Draft (21 Feb 2016)
REEVALUATION of The Lower Snake River
Juvenile Salmon Migration Feasibility Report
And
SUPPLEMENTAL Environmental Impact Statement

Appendix D
Natural River Drawdown Engineering

Prepared by
Jim Waddell, PE/CE, USACE retired, Lead Author
John Twa, ME, Technical Support/Editing/Graphics
Anon Fisheries Biologists & Planners, USACE

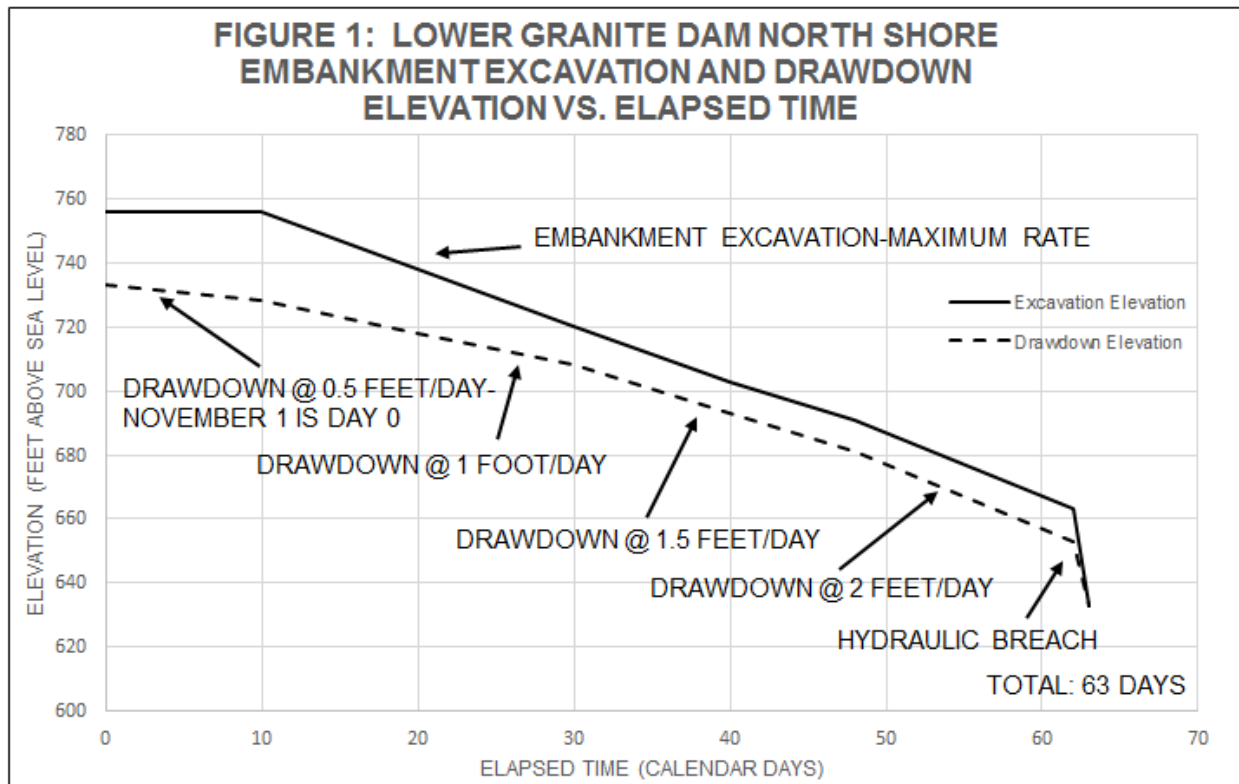
The pool of each dam will be held at MOP for two months prior to further drawdown, beginning on 1 November, 2016 for Lower Granite, followed by Little Goose on 1 November, 2017, Lower Monumental 1 November, 2018 and Ice Harbor 1 November, 2019. These drawdown dates are chosen as having the least impact on fish passage, as very few fish are migrating during this time of the year. On these dates drawdown will proceed at 6 inches per day for 10 days, then at 1 foot per day for 20 days, then 1.5 feet per day for 18 days, then 2 feet per day for 14 days. (See Figure 1.) At this point, Lower Granite’s

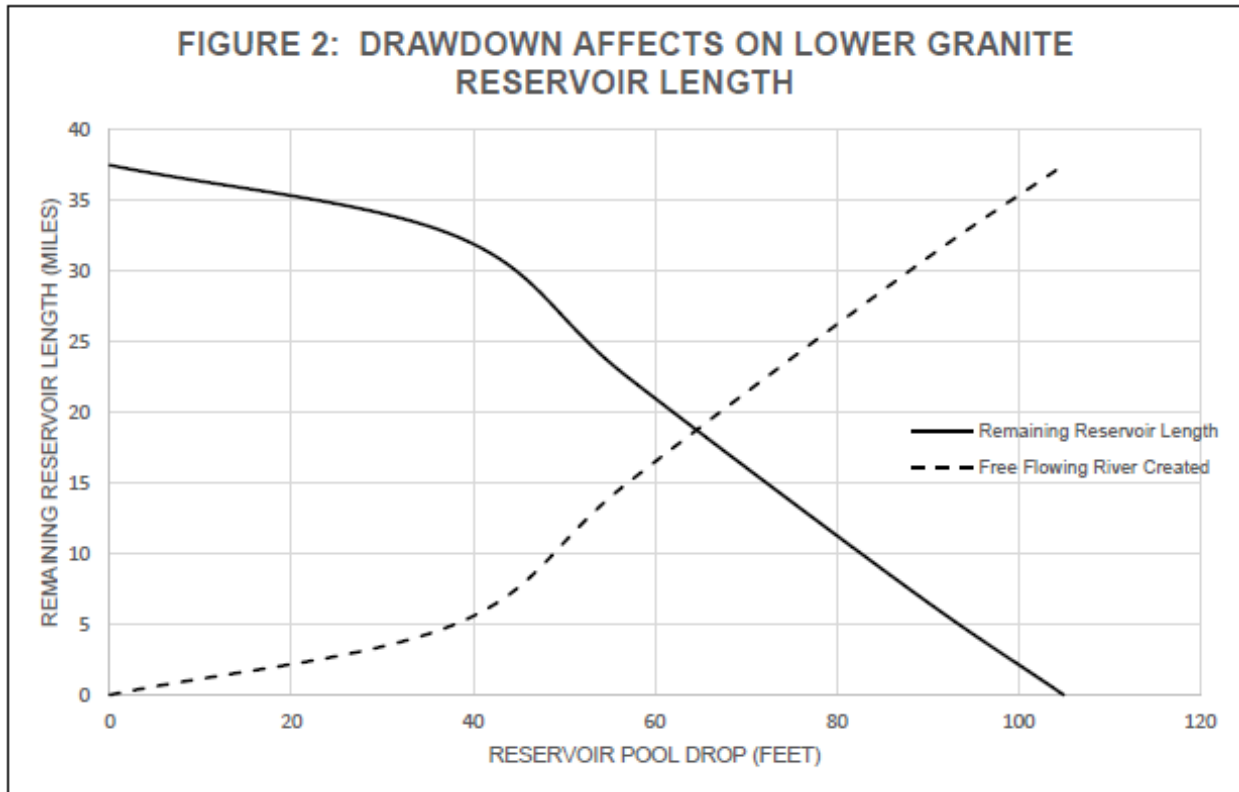
reservoir volume will have been reduced by 85% and the reservoir length reduced from 37 to 12 miles. (See Figure 2.) Lowering the reservoir to 653 feet mean sea level (msl) allows 10 feet of freeboard during embankment excavation at all times for safety. On 2 January 2017, the reservoir will be allowed to rise 10 feet and overtop the 30 foot wide notch that has been excavated into the embankment. The controlled hydraulic breaching of the earthen embankment will lower the reservoir the last 30 feet in a matter of several hours. Drawdown will be complete with channel widening continuing for several weeks to a few months, depending on flow conditions.

FIGURE 5: LOWER GRANITE DAM BREACH PLAN (AERIAL VIEW)

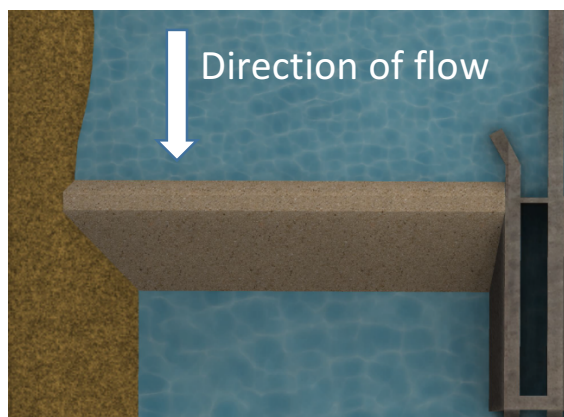
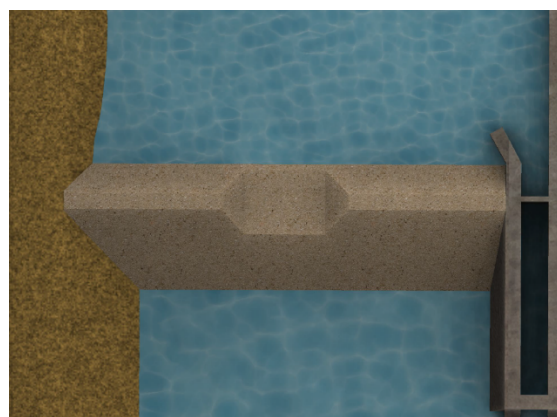
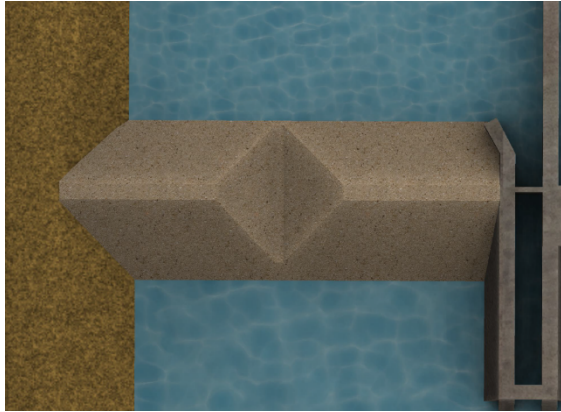
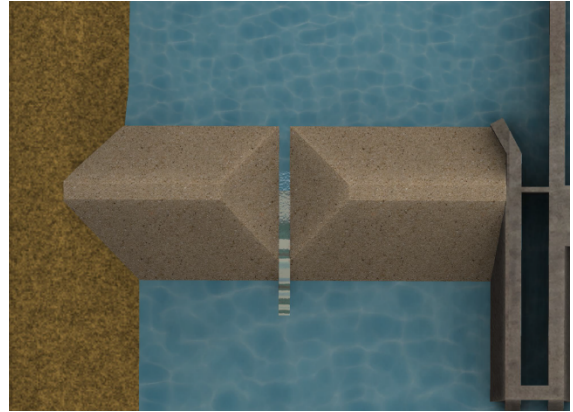
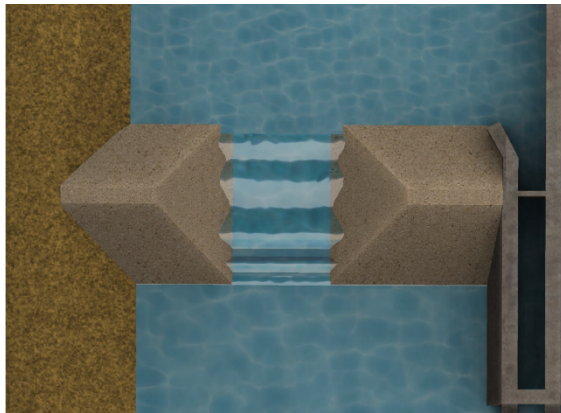
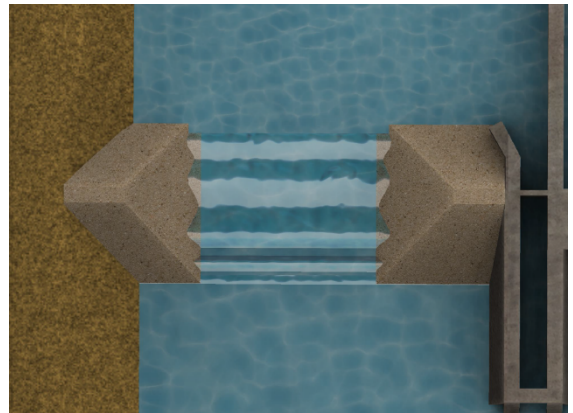
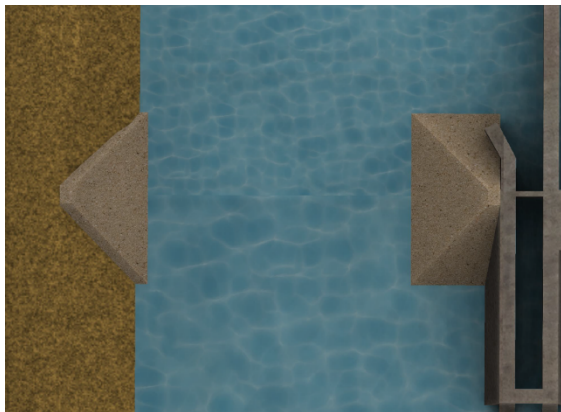
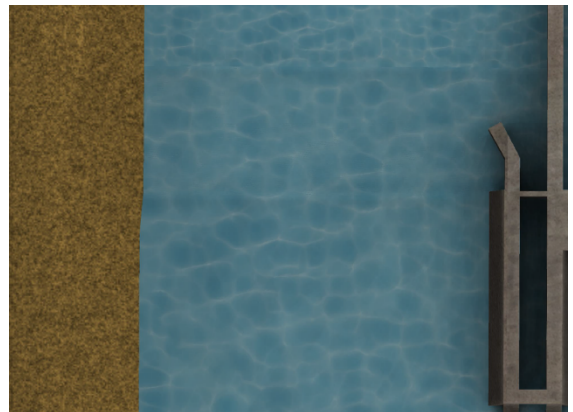
The LSFR Appendix D & Annex B assumed that the breach would be accomplished by removing the embankment material to an offsite location up to 2 miles away. Given the short duration required to excavate/move the material, a large force of oversized equipment was necessary, working two 10 hour shifts 6 days per week. This plan provides for a much simpler and cost effective approach. Prior to drawdown on 1 November, the road and other infrastructure will be removed and the riprap on the downstream side of the dam will be pulled down and loaded on barges for possible use as dike material (See River Channelization.) Given the sand and gravel nature of most of the material, which is the same or similar to normal bed material as the 100 million cubic yards deposited at the confluence of the Clearwater and Snake, embankment removal will begin with two D-8 dozers and one large bucket loader pushing the embankment material over the downstream slope until the earthen berm is lowered 80 feet. At this point a controlled hydraulic breach will begin by closing the turbine wicket gates. As the water level rises and flows through the embankment cut, hydraulic erosion will cause a headcut in the embankment to migrate upstream for ~5 hours until it meets the upstream face. At this point discharges peak at 150,000 cfs for about 15 minutes and drop off to 50,000 cfs (natural river flows) over the next 3 hours as the notch or embankment opening widens. Figure 3 shows the breach flows and channel widening in the first 24 hours following breaching. Figure 4 shows channel widening over time with increasing flows. Widening will continue with the higher flows in early spring. It will reach a stasis width of 400+ feet with flows of 120,000 cfs, and 700+ feet with flows of 200,000 cfs. Hydraulic modeling shows that notching the embankment will be the most cost effective and predictable method. Figure 5 illustrates the breaching process.
